Committees: Streets and Walkways Sub [for decision] Operational Property and Projects Sub [for decision]	<b>Dates:</b> 5 July 2022 20 July 2022
Subject: Mansion House Station Environs - Little Trinity Lane public realm enhancements Unique Project Identifier:	Gateway 3 Regular Issue Report
PV Project ID: 11945	
Report of: Executive Director, Environment Report Author: Leila Ben-Hassel	For Decision

Core Project Name: Mansion House Station Environs: Little Trinity Lane

• Current design proposal (approved by committees GW3 in December 2018)

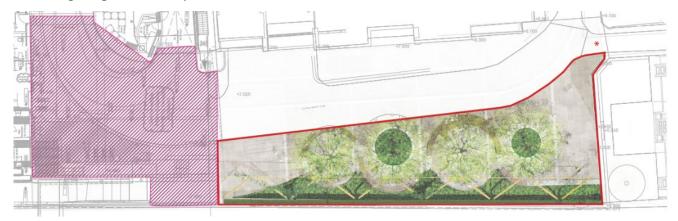
This design is proposed to be reviewed as part of this Issues' Report to refocus the benefits of the project to align with the City's Climate Action Strategy objectives and the Cool Streets and Greening Programmes requirements

Area of s278 repaving works associated with Hotel (outside of project) The proposed revised scope includes some footway widening but these works are not as significant as proposed at Gateway 3 due to the loss of TfL funding. The scope of the architectural lighting is also proposed to be reduced.

The proposed revised scope excludes any significant alterations to the southern boundary retention wall along Upper Thames St. The design review will focus on delivering environmental benefits aligned with the City's Climate Action Strategy and the Cool Streets and Greening Programme. The following will be explored for inclusion in scope:

- SuDS including raingardens, channels and re-profiling of footway,
- Retention of mature trees and enhancement of their setting,
- Increasing greening including climate resilient planting and species that help mitigate pollution,
- Pollution mitigation green screen hedge or planted pergola and biodiversity enhancements.
